ChiCycle Questions, Observations, Recommendations and Objections to the S106 Modifications to the Mini Roundabout at the Junction between Sherborne Rd and Westgate

2020 Summer Infrastructure Steering Group Community Consultation

Please see 19183-WGSR-SK002 P4 Westgate/ Sherborne Road Revised Layout drawings for context

15 July 2020

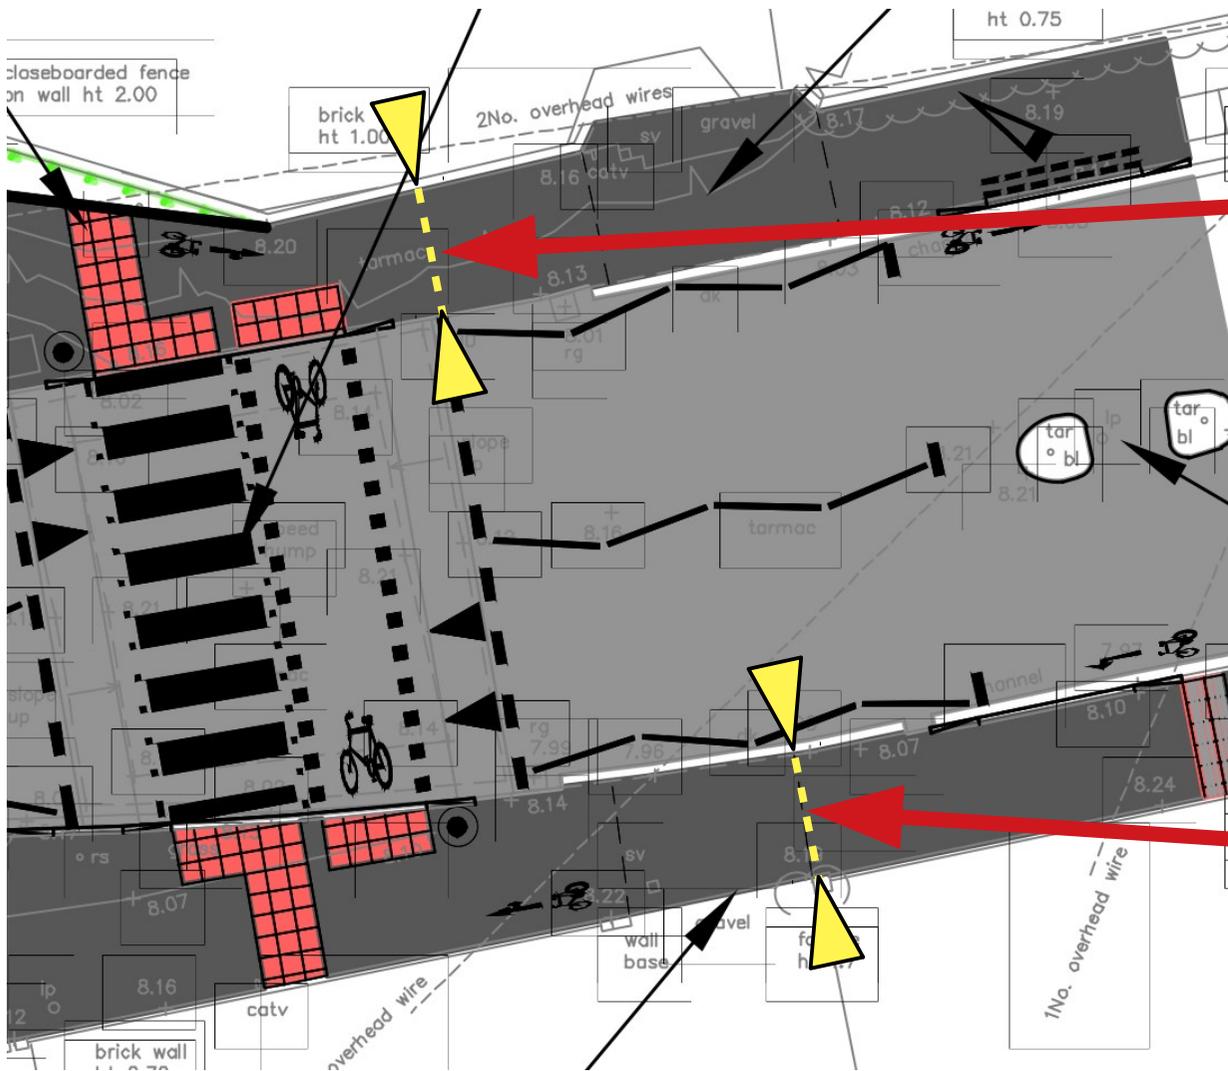
Q3) What is the reason for widening the radius of the western limb of this roundabout? Currently there is no agreement to connect the Southern Access Spine Road at this junction! The existing geometry is adequate for school buses so why change it?

Since there are no agreed plans for the Southern Access Road to join this mini roundabout, Why is the tuning radius into its western limb being increased to suit heavy vehicles?

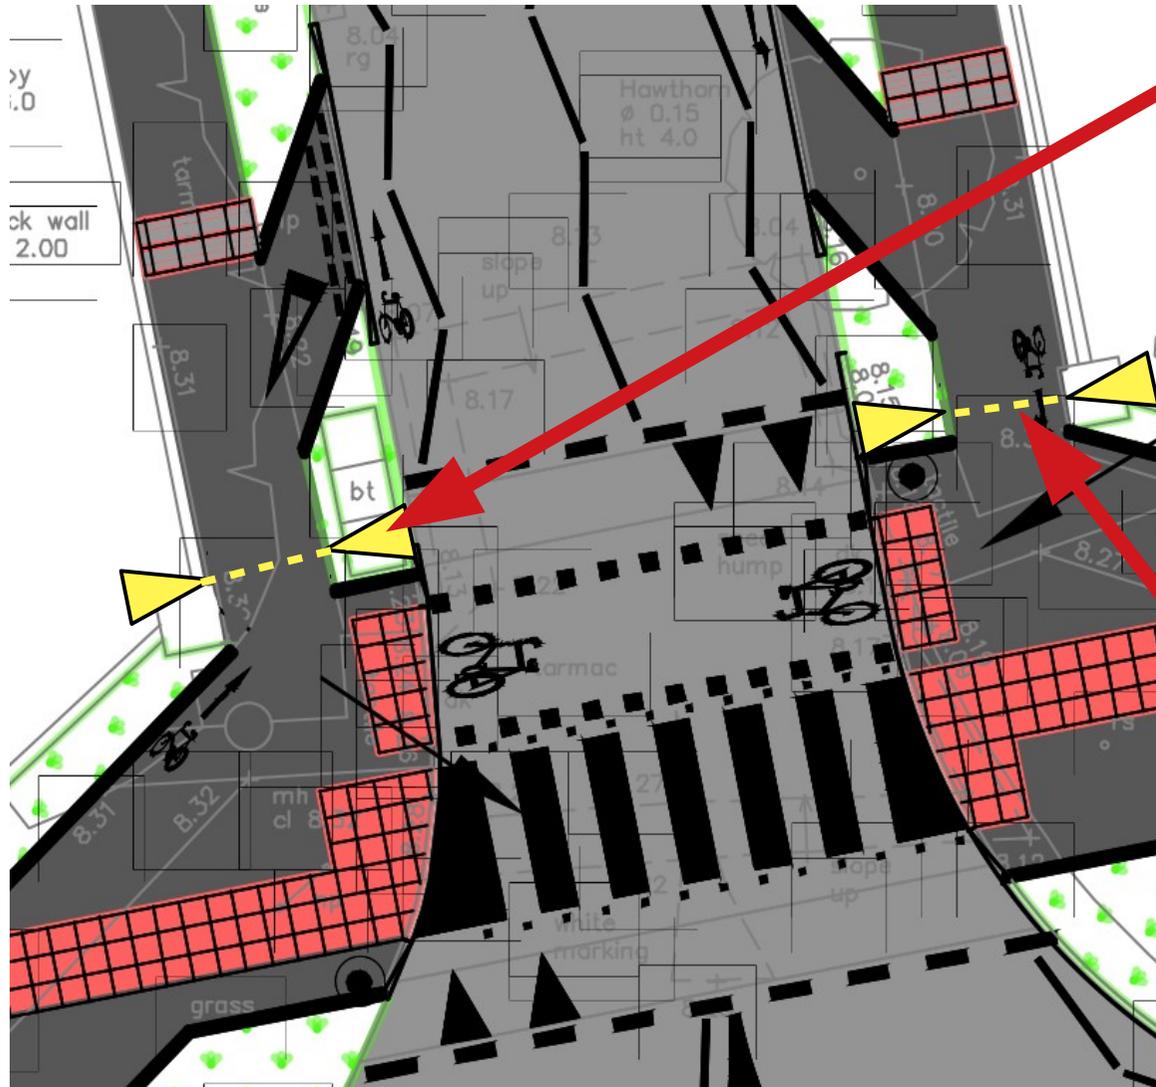
Q4) Siting a cycle track along existing narrow pavements will unacceptably disadvantage many pedestrians. Why do many sections of cycle track shown in the plans fall below the DfT LTN 01/12 minimum specified widths for shared use tracks?

2.15 metres = Actual width

1.45 metres = Effective width with allowances for vertical features following LTN 01/12 guidelines

3.0 metres = The DfT minimum effective width for shared use cycle tracks/pavements (2.5m effective width only considered suitable for remote locations)

Width is **48%** of DfT minimum

Q5) Brick Wall and Cycle Track Geometry Cause Dangerous Bind Corners

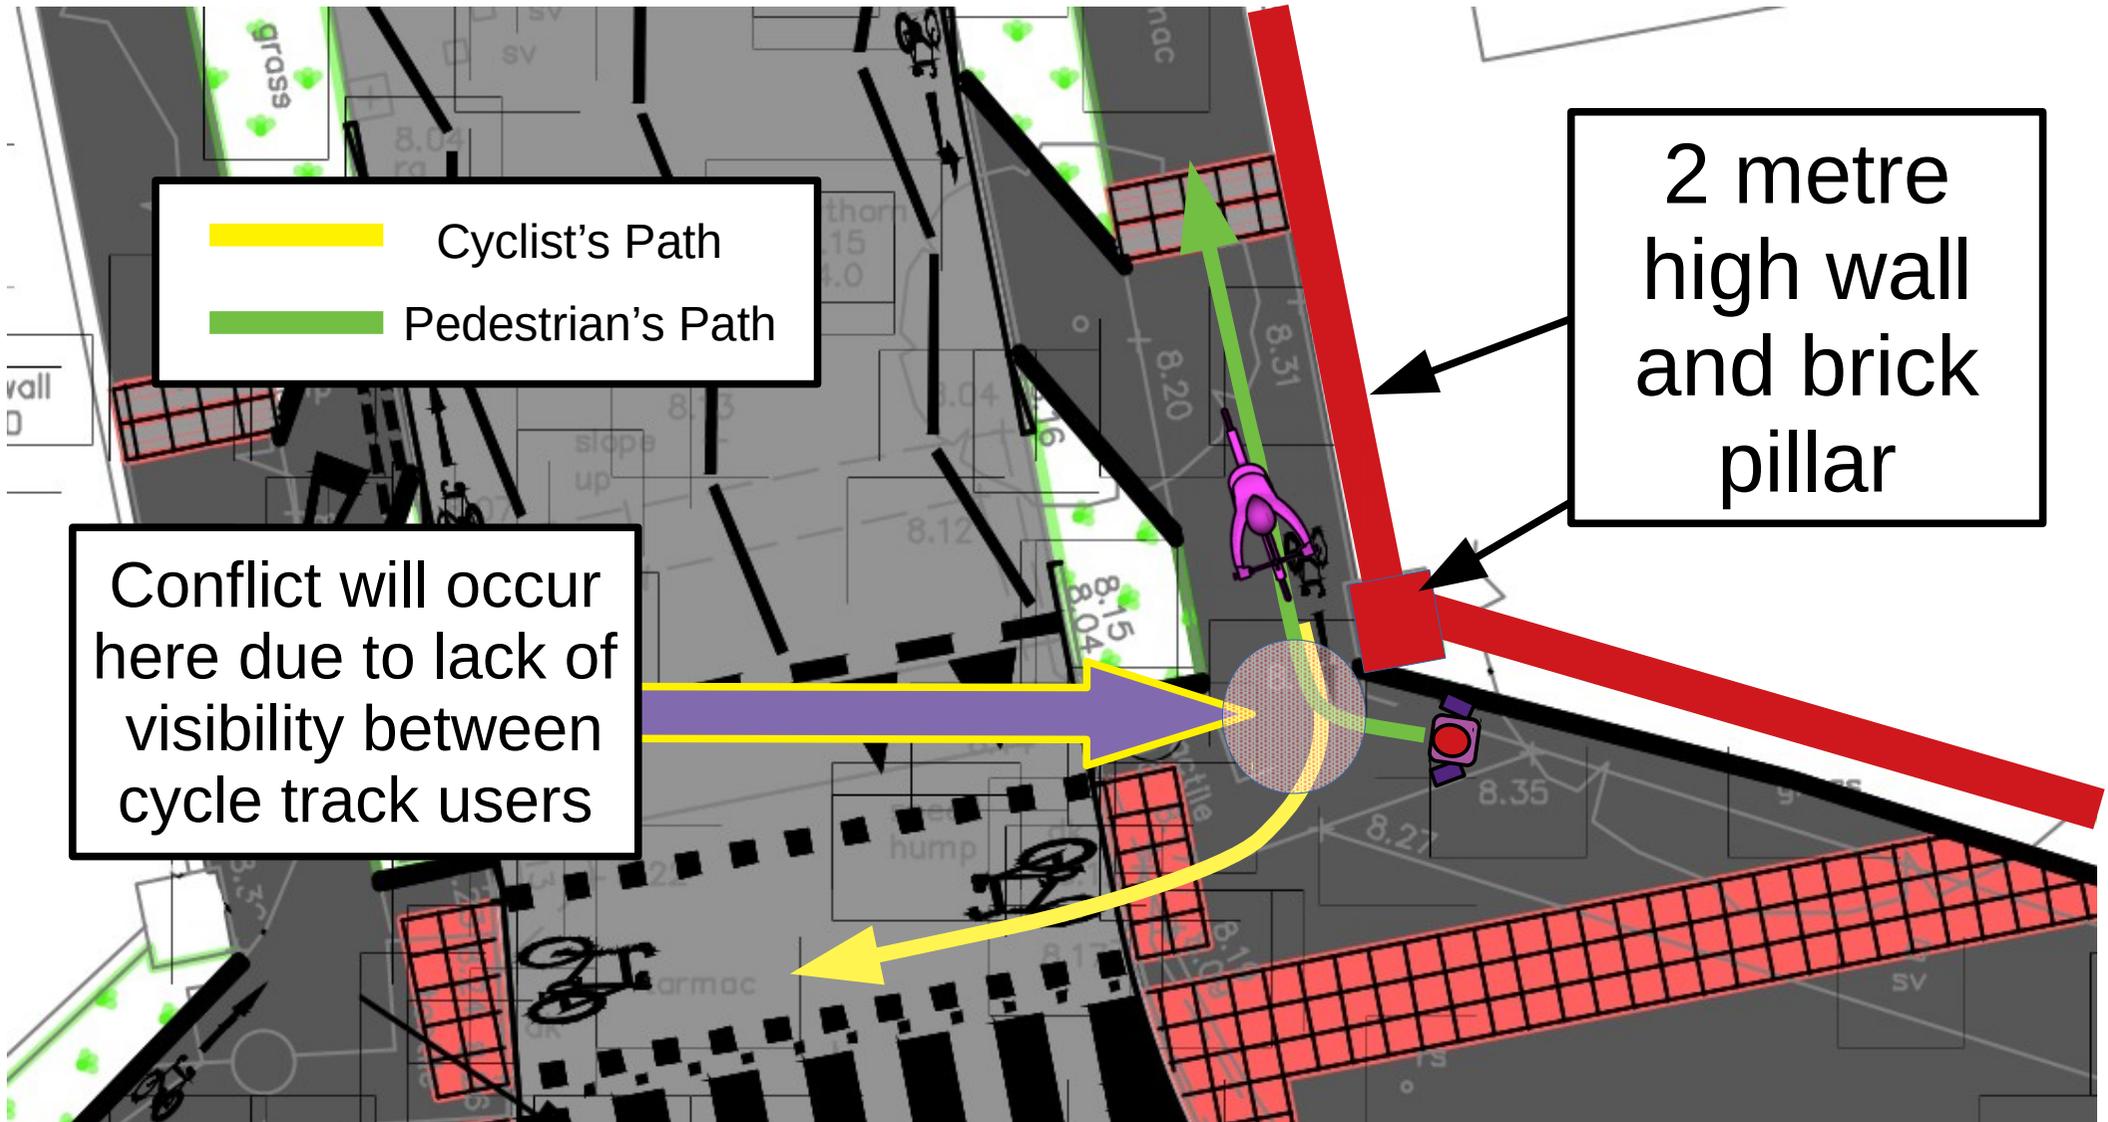
- 5) The proposed cycle tracks run close to brick walls and pillars. This will unacceptably restrict cyclists forward visibility of other cyclists and pedestrians at the roundabout. Will these walls be lowered to below 600 mm or removed to provide adequate forward visibility SSDs on the proposed cycle tracks? Has a splay analysis been completed for pedestrian/cyclists

Q5) Brick Wall and Cycle Track Geometry Cause Dangerous Bind Corners

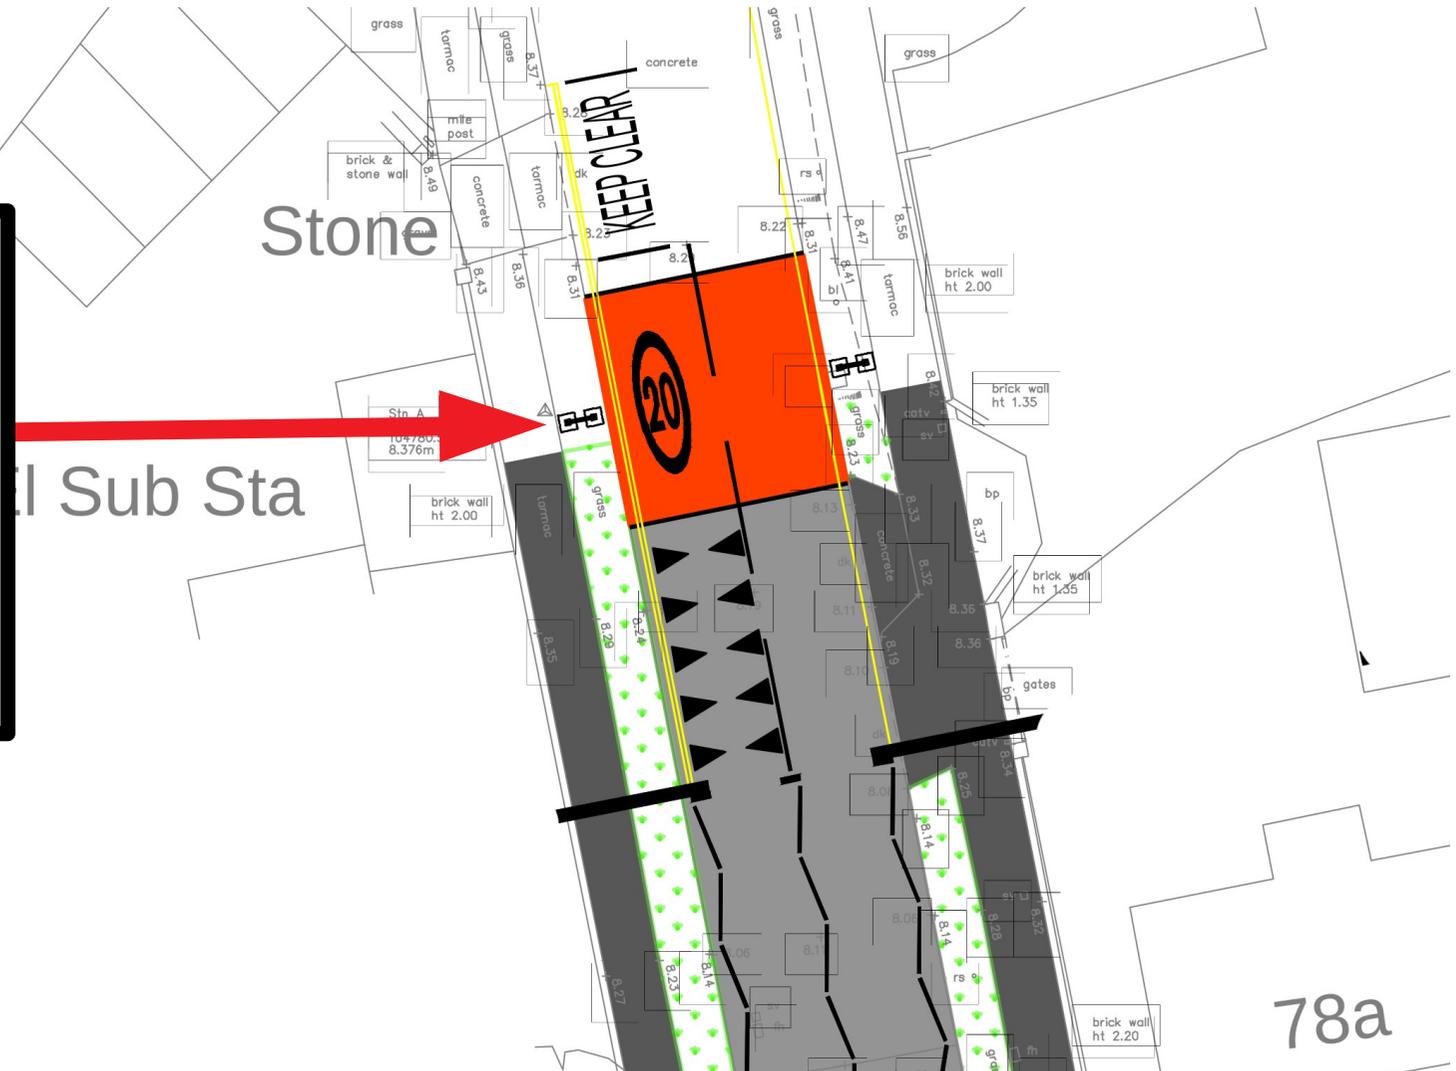
The photos below show the visibility issues where the proposed tracks will run. The plans indicate cyclists are expected to cycle around these pillars potentially into the paths of pedestrians

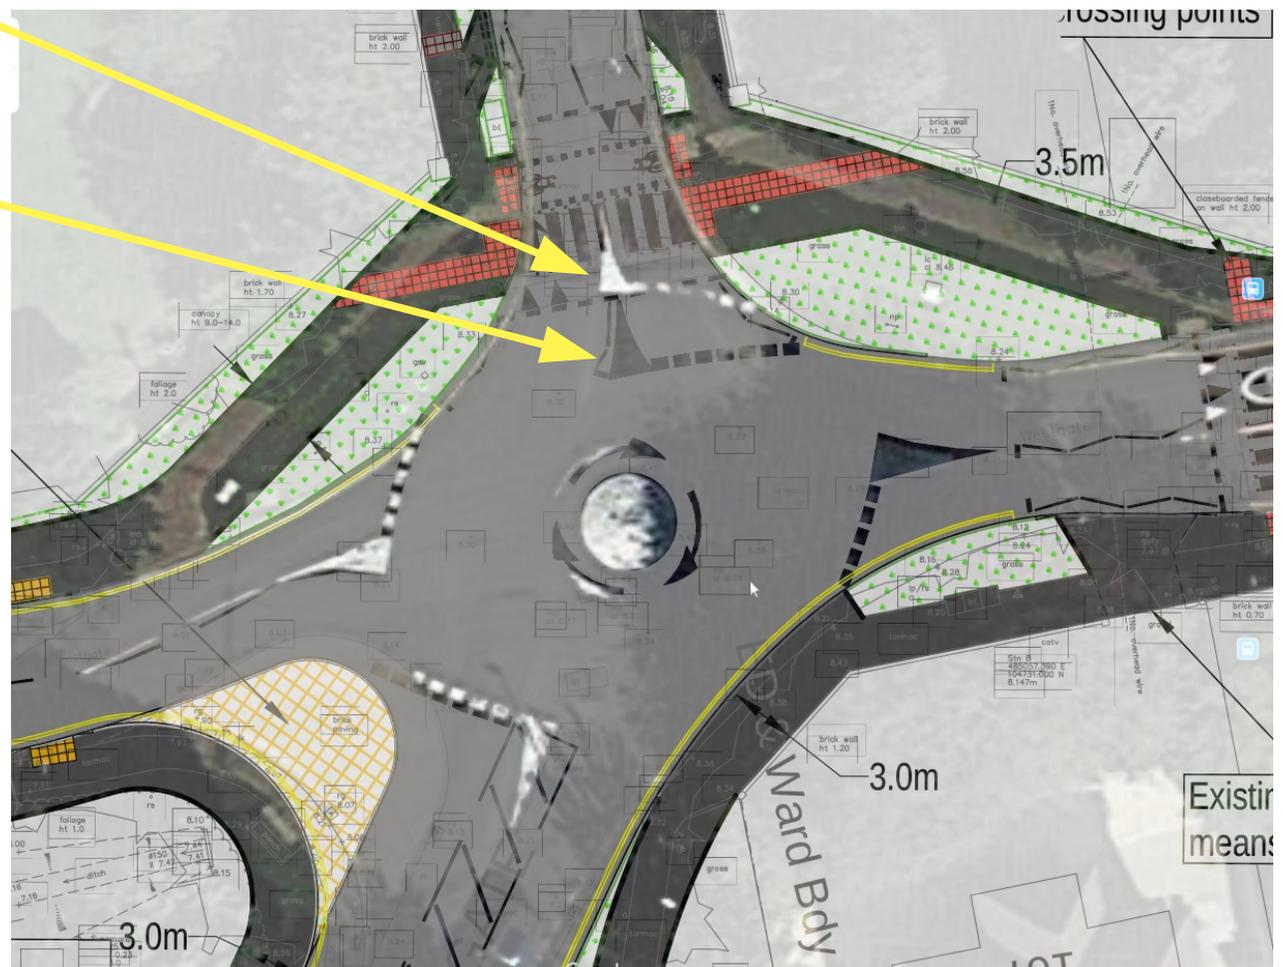
Q7) The toucan crossing on the roundabout's northern limb is unacceptably close to the roundabout. The plans indicate the give way line will be moved forward into the middle of the roundabout lane to give the appearance the toucan-crossing has greater separation from this junction than it really has. Does moving the give way line into the roundabout really give satisfactorily separation between the crossing and roundabout?

The white lines shown on the image to the right are taken from an aerial photograph

The dark lines shown are from drawing 19183-WGSR-SK002-P4 - Revised Layout.pdf

The two images have been merged to give a composite image.

As can be seen the give way markings have been moved away from the existing speed table that is to be repainted as a toucan crossing.

The distorted shape of the roundabout now appears like a swashed rugby ball.

Is this flattened geometry really acceptable as a workable roundabout arrangement?
